RE: ITB No. 21-101, Murphey Candler Park- South Trail

Please see Addendum No. 1 for the above-referenced solicitation.

ADDENDUM NO. 1
Invitation to Bid, No. 21-101
Murphey Candler Park- South Trail
REVISED 1/8/2021

COLLAPSIBLE BOLLARD
NTS

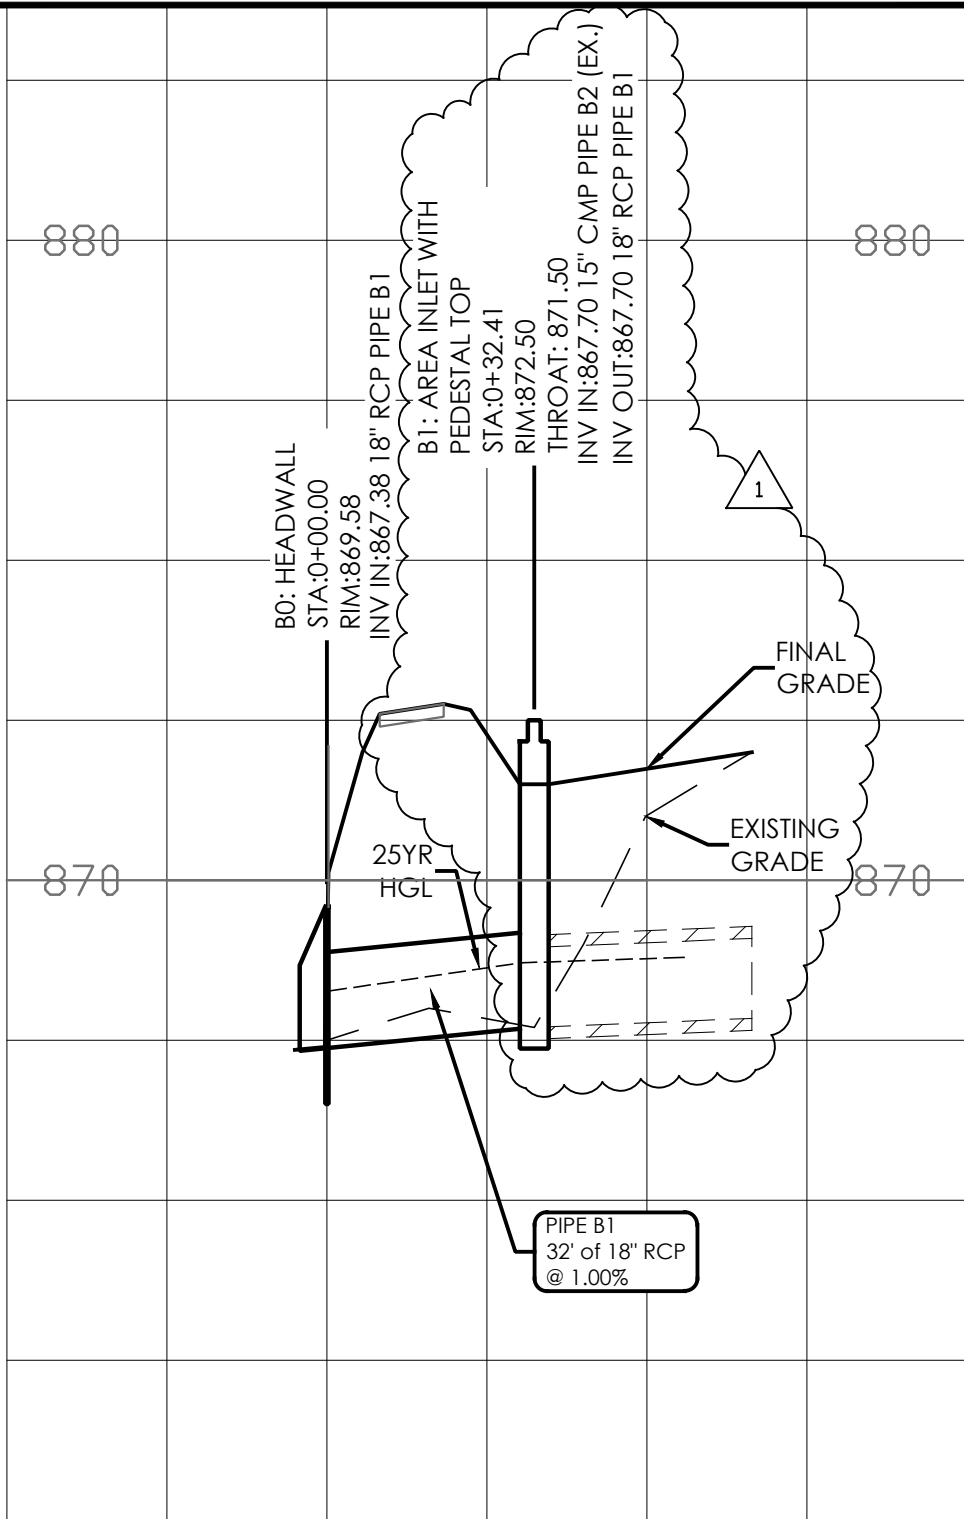
- **Spec for required Bollard (see attached Bollard Detail)**
- **Revised Storm B (see attached Profile B)**
- **Revised Construction Items, Drawing C2.5 (see attached Construction Items Sheet Revise)**
- **Revised drawings Cover Sheet, Drawing C0.5 (see attached Cover Sheet)**
- **Pre-Bid Meeting Notes**

DATE	DRAWN	CHECKED
01-06-2021	GZ	MC
SCALE	NTS	
SHEET TITLE		
SOUTH TRAIL ADDITIONAL ACCESS #2

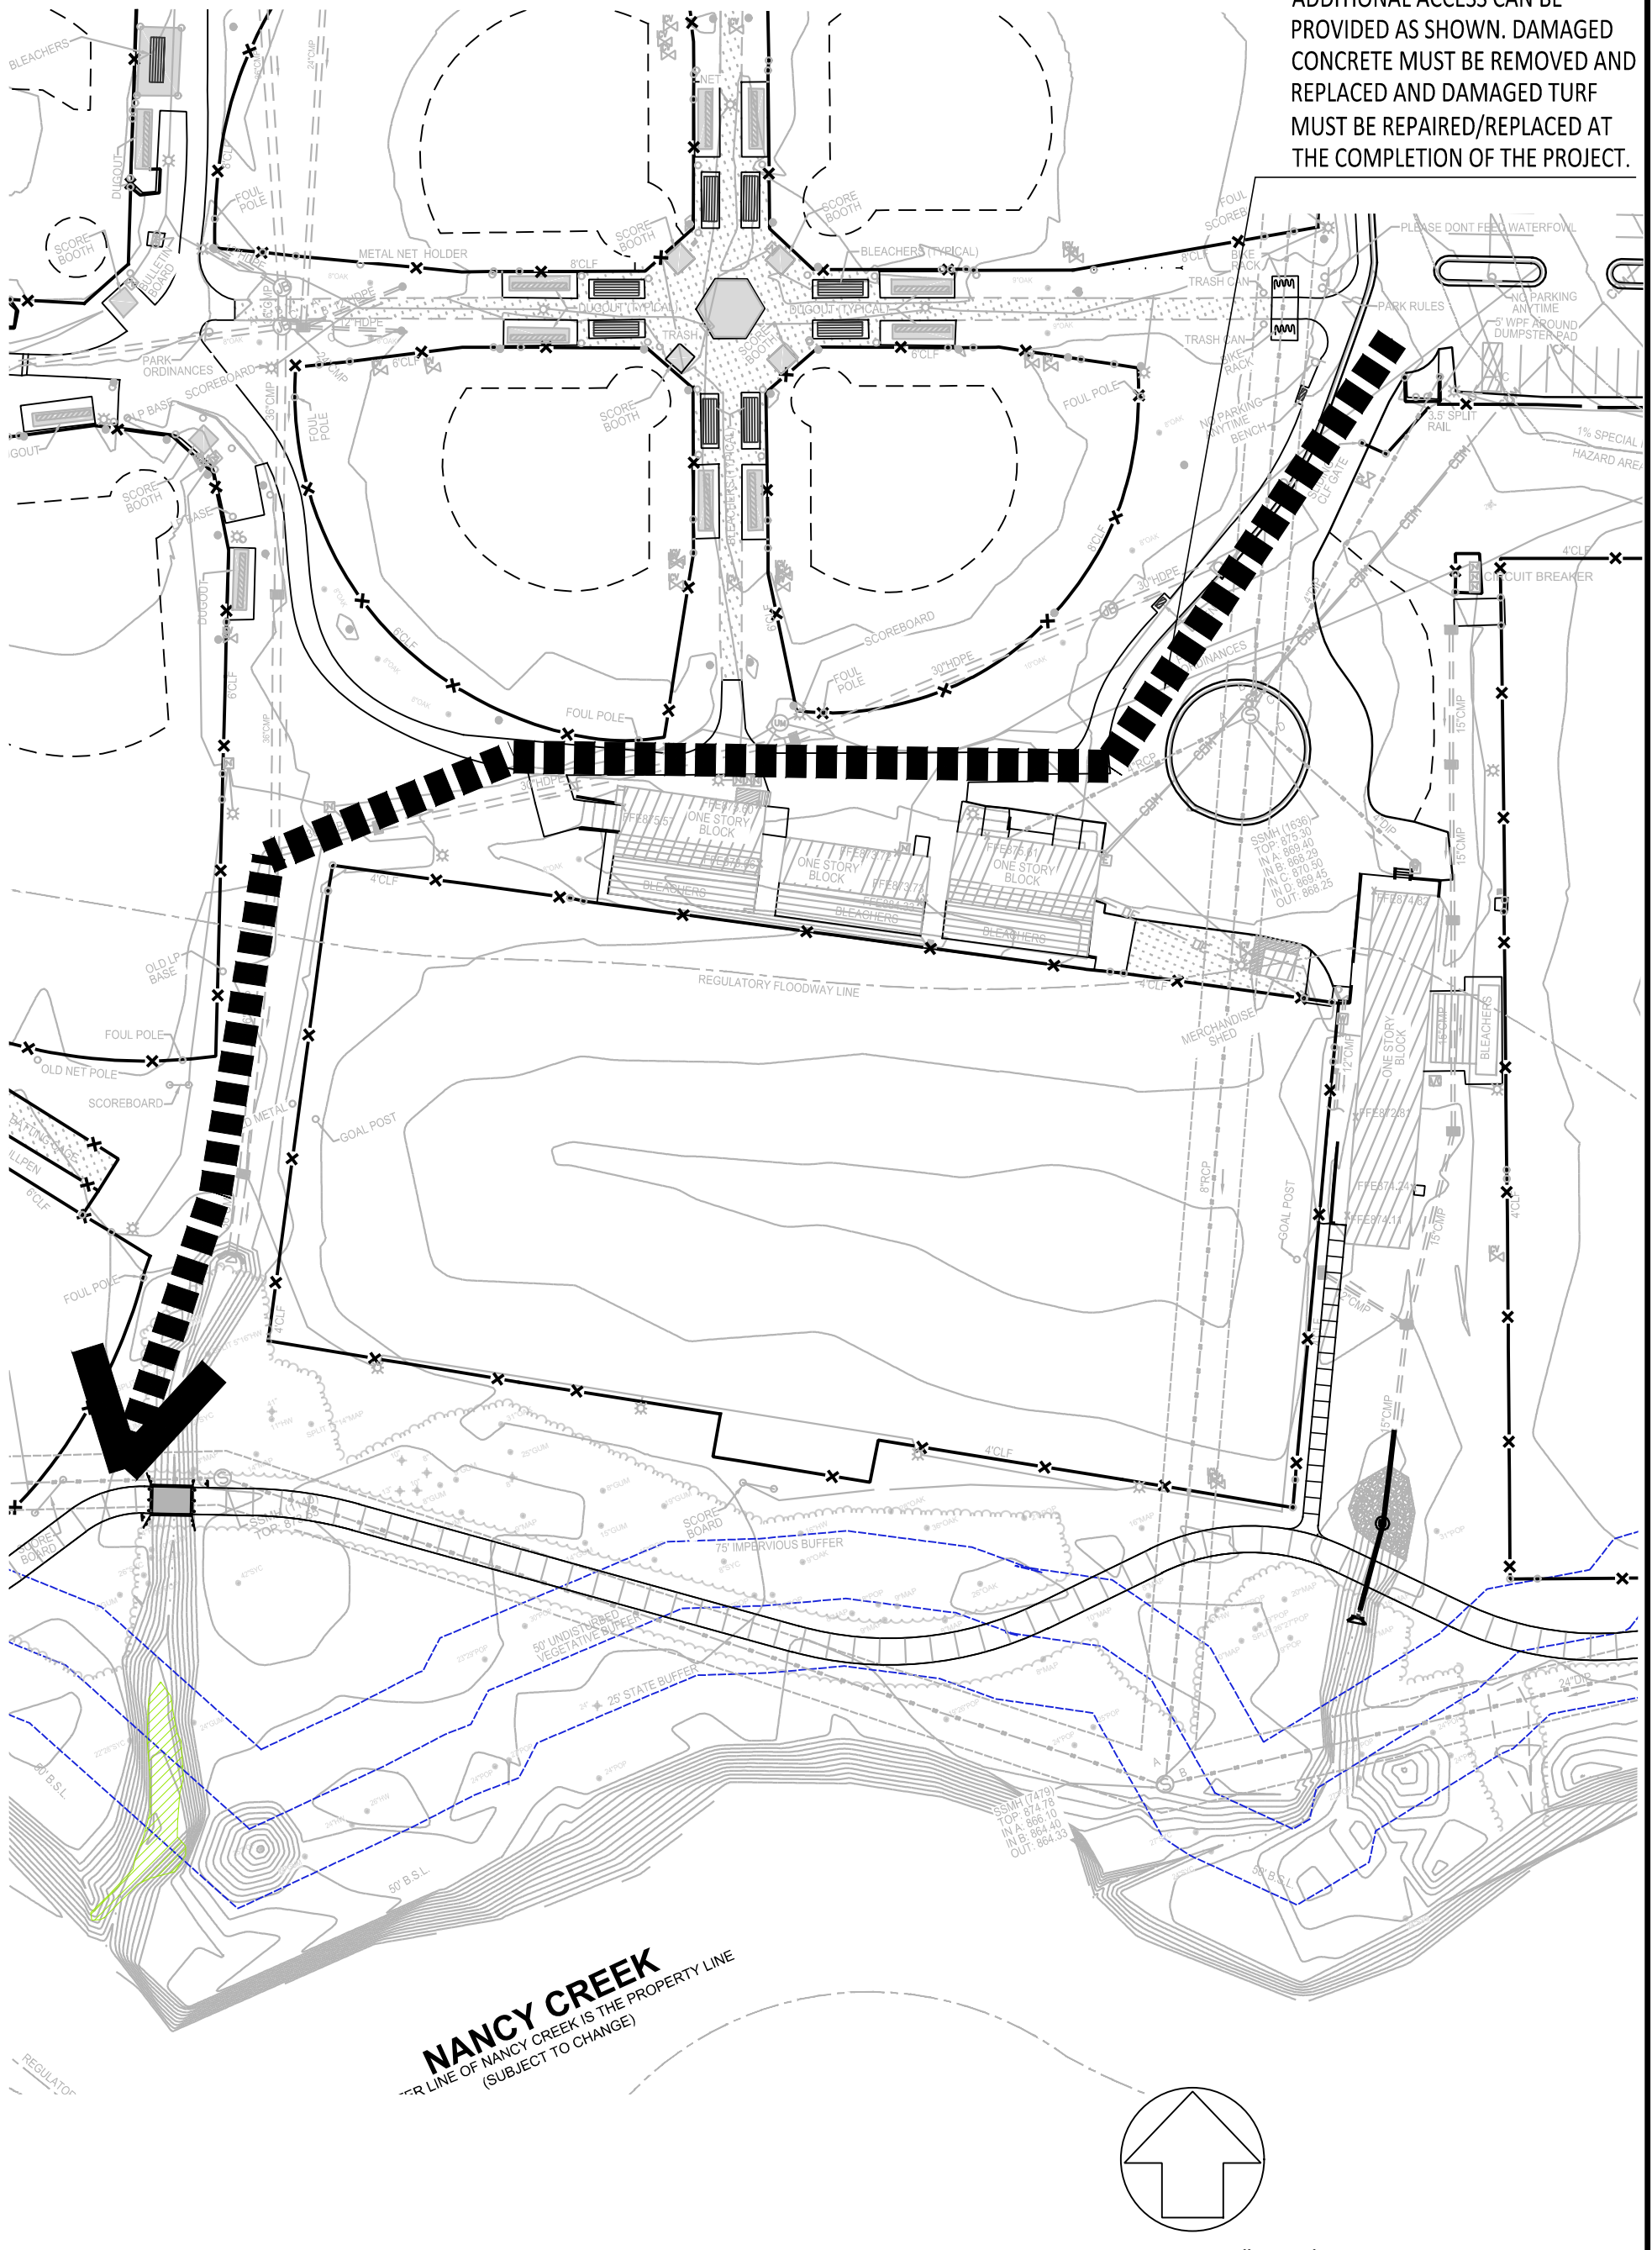
Pavement on the west side of the channel is a road and will handle the traffic, especially if reinforced with plywood. See attached Access Route #2.

ADDITIONAL ACCESS CAN BE PROVIDED AS SHOWN. DAMAGED CONCRETE MUST BE REMOVED AND REPLACED AND DAMAGED TURF MUST BE REPAIRED/REPLACED AT THE COMPLETION OF THE PROJECT.

DATE	DRAWN	CHECKED
01-06-2021	GZ	MC
SCALE	NTS	
SHEET TITLE		
SOUTH TRAIL ADDITIONAL ACCESS #1

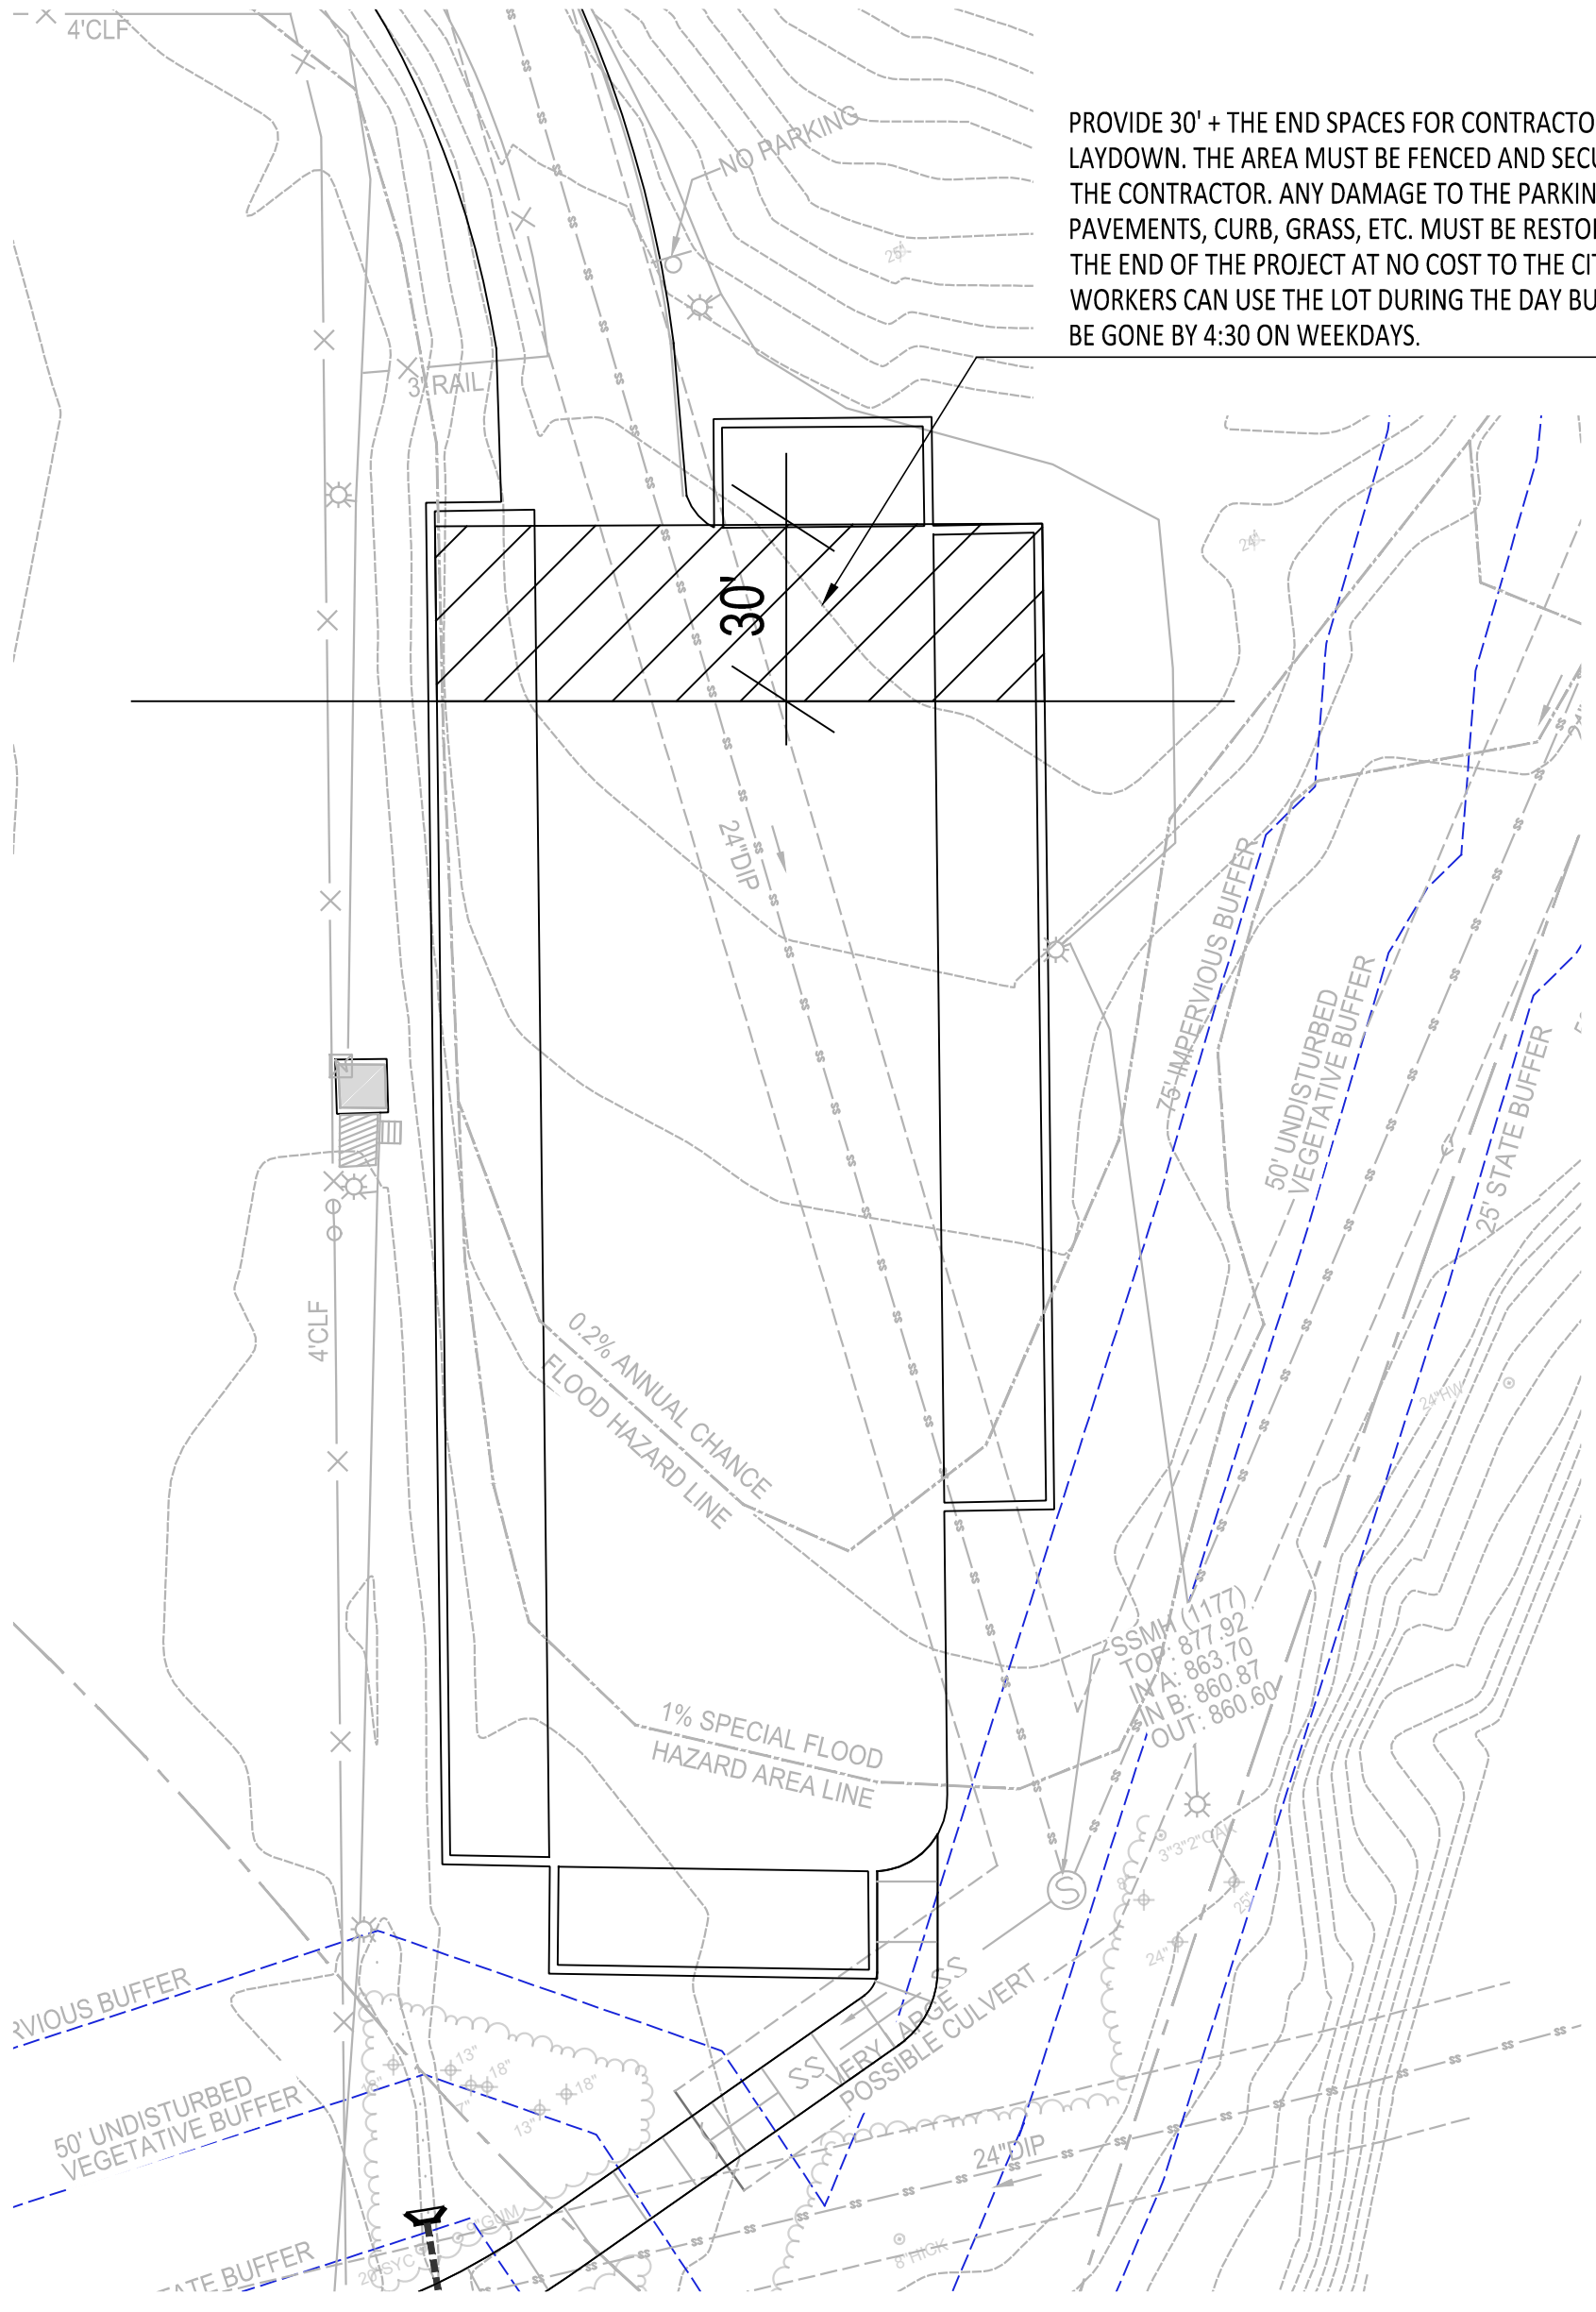
Attached is a route for additional access. (See Access Route #1.) Damaged concrete within the park must be removed and replaced and damaged turf must be repaired/replaced at the completion of the project. Access through the park must be cleaned daily. See allowance items added to the CIBS in question #3. Yes, if the conditions are wet, tracked loaders and excavators will be required to limit tandem truck traffic to avoid root damage to the trees. Pumping concrete will also be required if wet conditions limit concrete truck access.

ADDITIONAL ACCESS CAN BE PROVIDED AS SHOWN. DAMAGED CONCRETE MUST BE REMOVED AND REPLACED AND DAMAGED TURF MUST BE REPAIRED/REPLACED AT THE COMPLETION OF THE PROJECT.
